*Analysis and Report on Sections 4.1 through 4.6 of the Comments of the
Keweenaw Bay Indian Community (KBIC)—Final*

Prepared for the United States Environmental Protection Agency – Region 5

by The Cadmus Group, Inc. under contract # EP-C-08-015

September 2009

Figure 4-1. Cross section along transect E-E' through TWIS area.

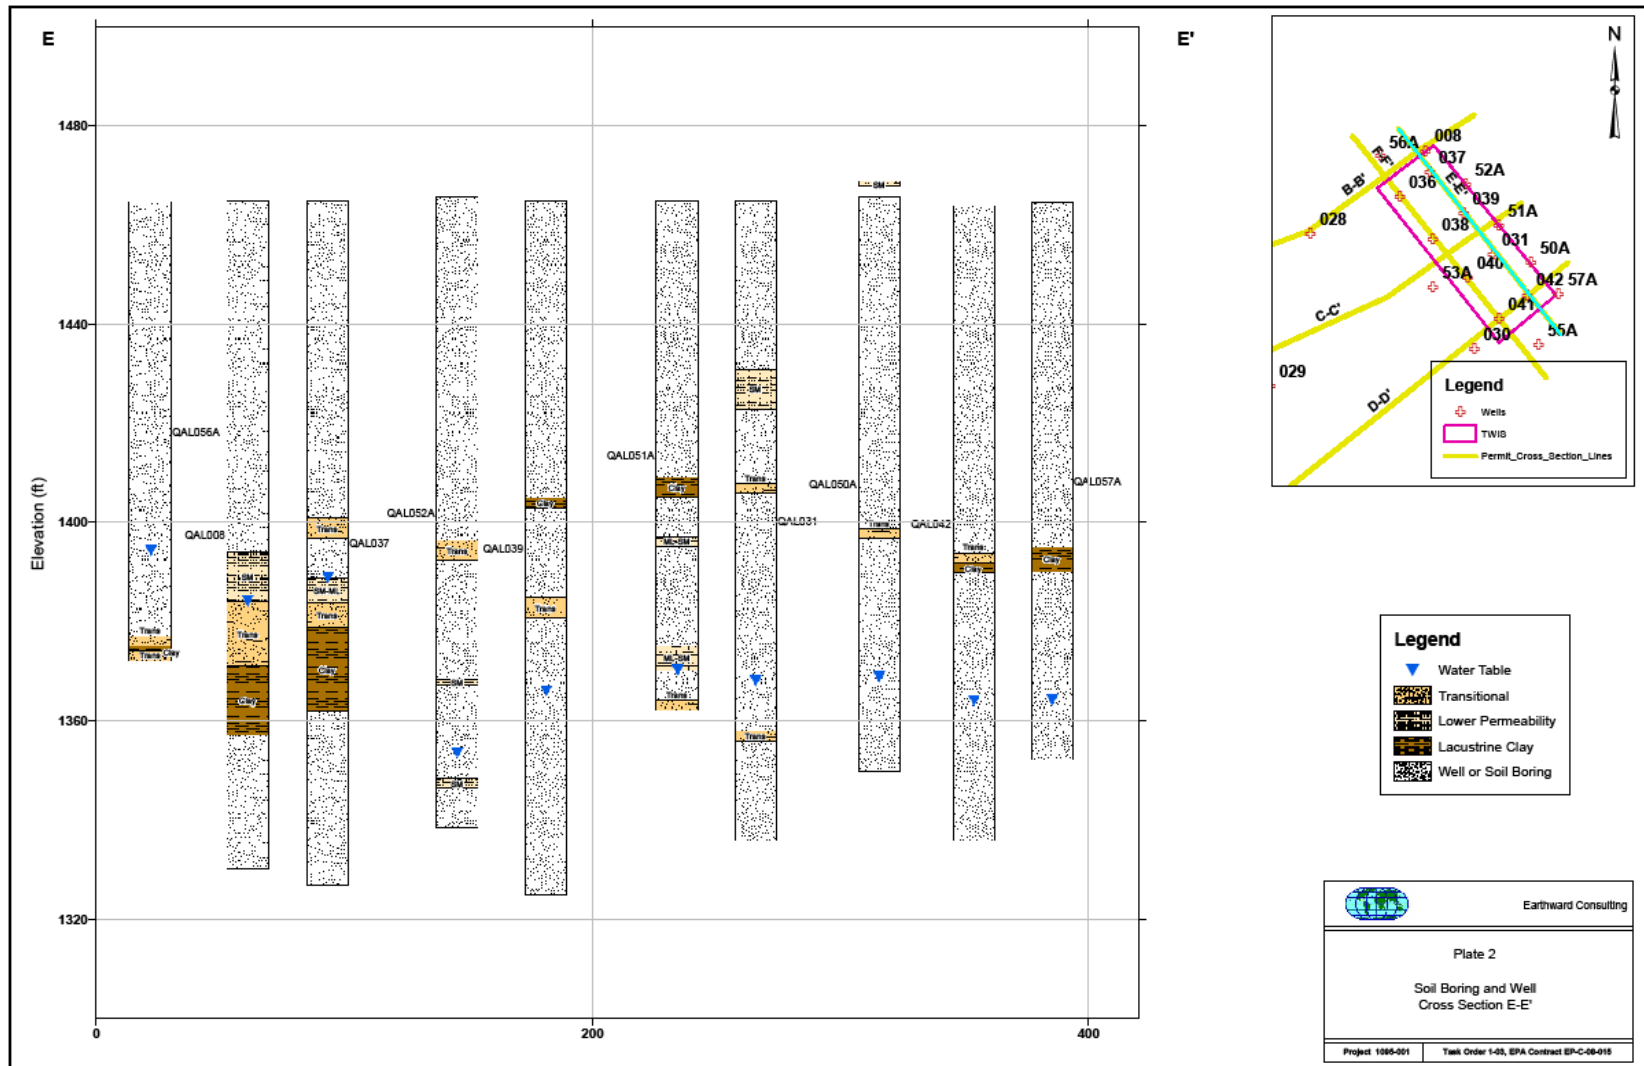
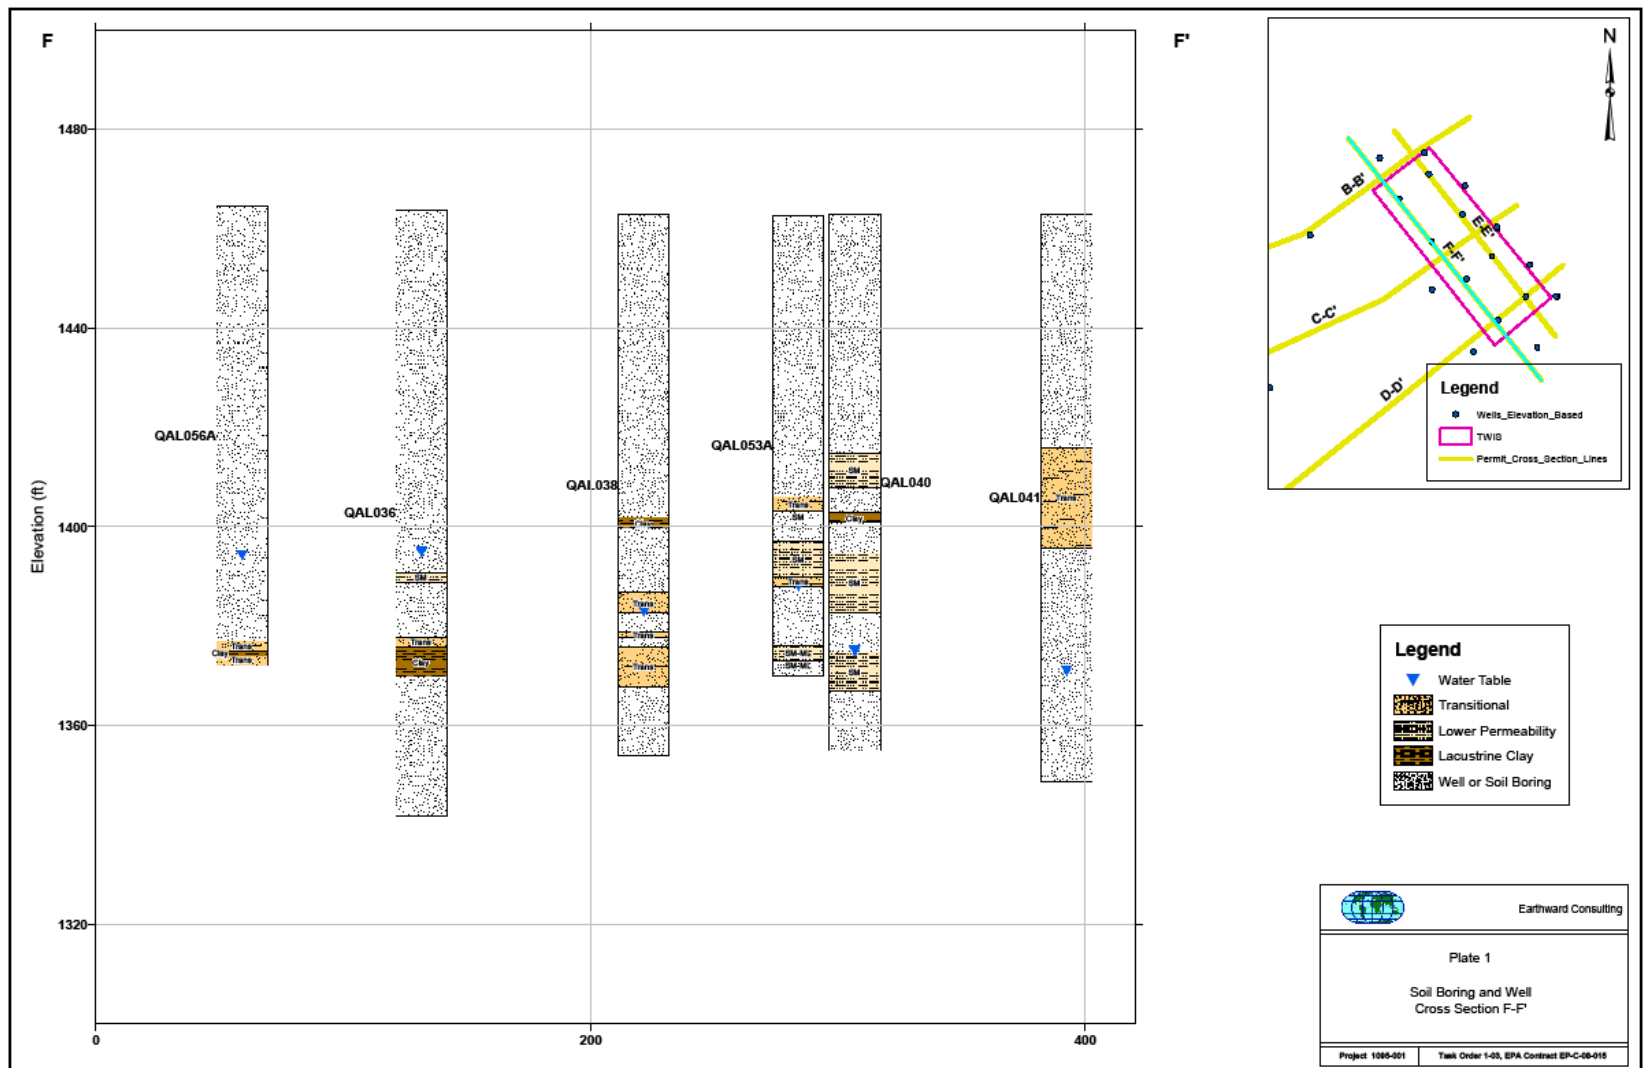
To address questions regarding the continuity of low-permeability sediments in the unsaturated zone underlying the TWIS, cross-sections were constructed using logs from soil borings and monitoring wells. These logs provide valuable information on the depth, thickness, and composition of the clay layer, the transitional deposit, and the lower permeability materials in the sandy sediments (e.g., those coded SM – silty sand). Using the program CrossView, stratigraphic data were projected from wells within a distance of 50 feet onto sections E-E' and F-F' (Figures 4-1 and 4-2) in the TWIS area.

Figures 4-1 and 4-2 show that the transitional layer, while present in most of the well and boring logs, does not occur at a consistent depth and is generally quite thin. Such an observation is consistent with the transitional deposit being present as discontinuous lenses and makes any argument for their continuity highly questionable. Silty sand layers (coded SM) in the unsaturated zone are similarly irregular (e.g., occurring at different depths in different logs, and appearing as one layer in some logs and two or three in others) in their appearance across boreholes. It is concluded that the lower permeability sediments are laterally discontinuous and significant mounding of treated wastewater that would breach the land surface is unlikely.

It should be pointed out that when evaluating the appearance of the lower permeability layers in the cross-sections, the subjectivity inherent in boring logs should be kept in mind. The transition between, for example, a sand layer and a silty sand layer may be gradual rather than sharp, and differentiation may be subtle depending on the difference in composition.

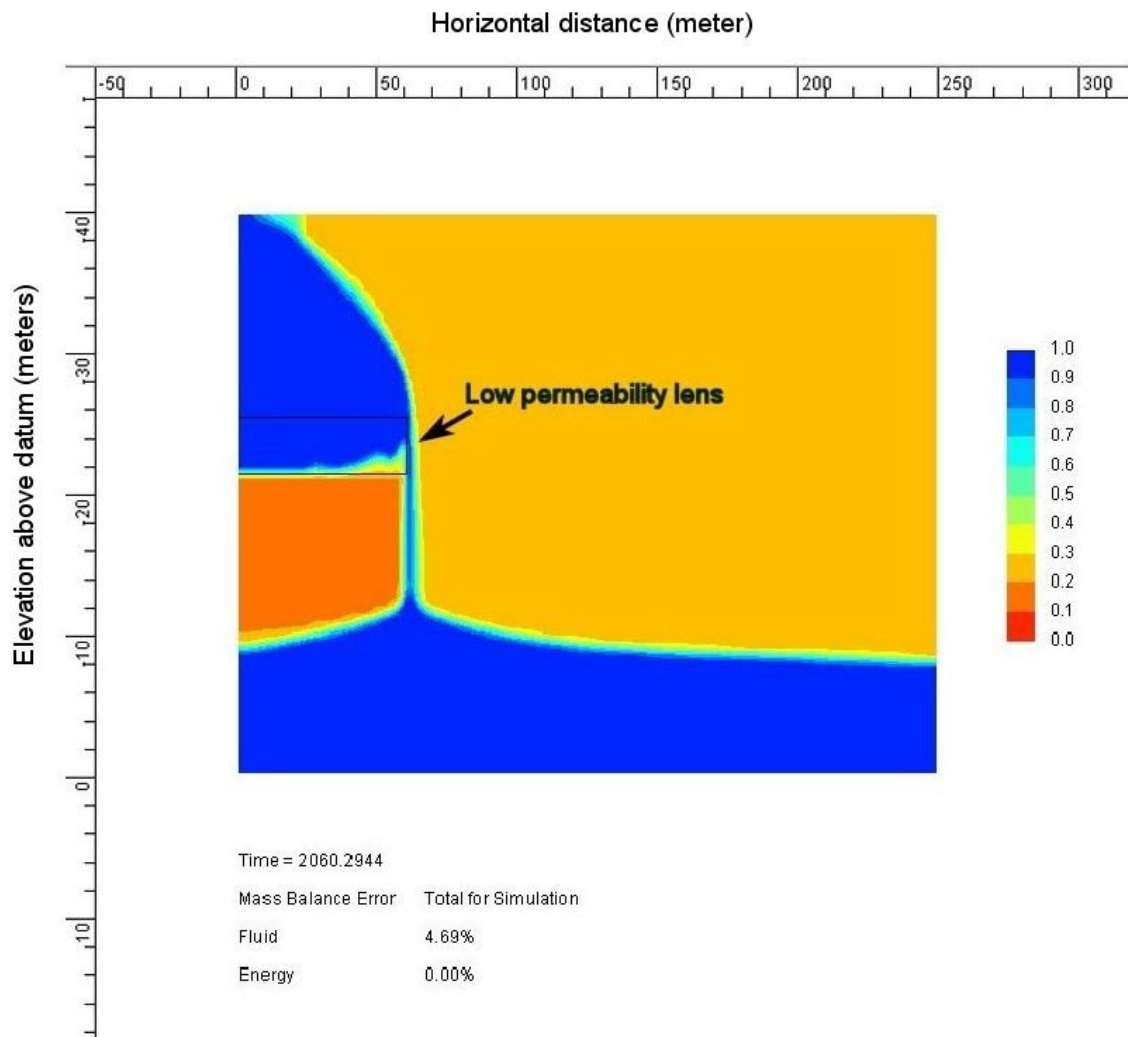
KBIC's consultants provided the results of their numerical simulations and also provided the two data sets used to generate those results. These data sets were used to re-run the simulation and verify the results. The graphics from the post processor shown below (Figure 6-1) match Figure 4.17 in the KBIC Comments. Note that there is a 2,000 day equilibration phase in the model before the 60 days of infiltration are simulated. This equilibration phase simulates the establishment of baseline conditions prior to infiltration.

Mass balance should ideally be less than 1%. Although not discussed by the KBIC Comments, these runs experienced mass balance errors of almost 5% (see Figure 6-1). The reason for higher error is most likely the time stepping or convergence control parameter selected. As is, the execution takes hours to run. Because of the strong hydraulic conductivity contrast (over two orders of magnitude), it is unlikely that revisions to achieve a lower mass balance would substantially change the overall model predictions.

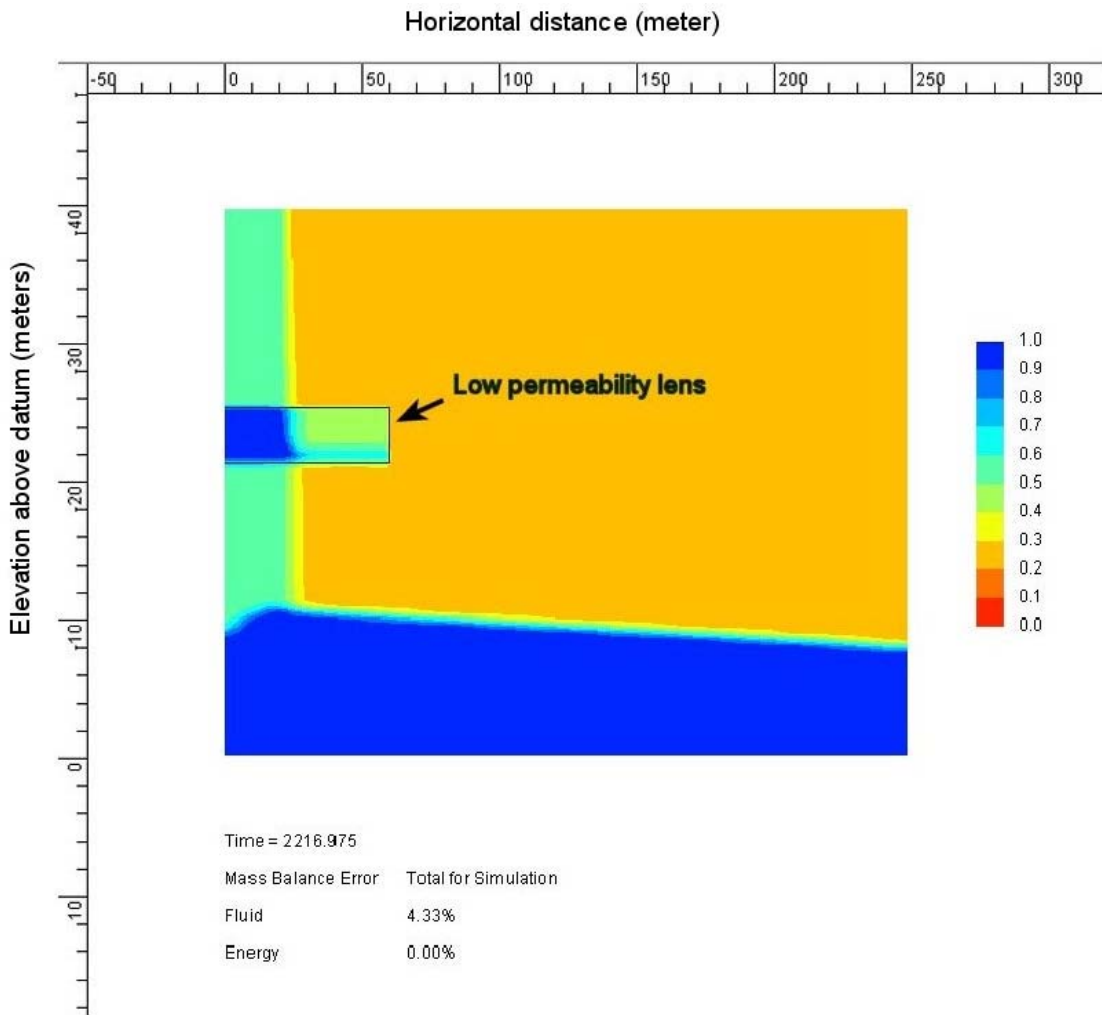
The model used by KBIC’s consultants is highly dependent on the assumed saturated conductivity of the silty sand (SM) material as well as the location and thickness of this unit. To demonstrate this, the assumed hydraulic conductivity of the silty sand was changed for this review from 0.009 m/day to 0.225 m/day, a value still within a reasonable range. (The value selected by KBIC’s consultants is the lower limit (0.00864 m/day) as taken from Fetter (2001; Table 4.3 of the KBIC Comments); the upper limit from this same source is 0.864 m/day.) Using

this alternative assumed hydraulic conductivity changes the ratio of the hydraulic conductivities of sand and silty sand from 233 (=2.1/0.009) to 9.3 (=2.1/.225). In the model, this involved selecting a silty loam soil instead of “silt CP” for soil type.

The simulation was re-run with all other parameters unchanged. First, a 2,000 day equilibration period was simulated. Subsequently, infiltration was simulated using the same TWIS recharge rate for a period of 217 days, allowing conditions to stabilize. Unlike the case reported in the KBIC Comments, the results do not exhibit flooding near surface conditions (100% saturation), but rather a 50% saturation as show below (Figure 6-2).

Figure 6-3. Taken from Bower (2002, Figure 10).

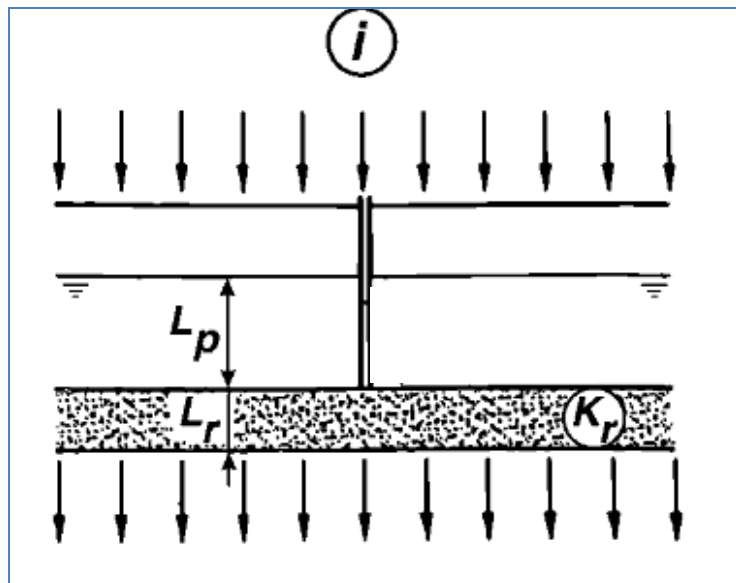
Assessment of the hydraulic conductivity value in the lower-permeability sediments that might lead to mounding to the surface can be done based on work by Bower (2002) (Figure 6-3):

This calculation produces a limiting hydraulic conductivity of 0.18 ft/day. Assuming a 13-foot thick lower-permeability layer, there will only be flooding at the ground surface due to mounding if the hydraulic conductivity of the 13-foot layer is less than 0.18 ft/day (0.06 m/day). This value lies approximately half way between the upper and lower bounds for hydraulic conductivity for silty sand given by Fetter (2001) (Table 5-1), and towards the lower end of the range given by Freeze and Cherry (1979) (Table 5-1). As noted above, Kennecott’s consultants had used the lower bound of Fetter’s values in their modeling. The conclusion that a hydraulic conductivity of 0.18 ft/day could cause mounding to the ground surface also assumes, as stated above, that a lower conductivity layer is continuous. As discussed in previous sections, the genesis of the subsurface sediments at the site and the stratigraphy as described in the boring logs and cross sections strongly suggest that such a continuous layer does not exist in the TWIS area.
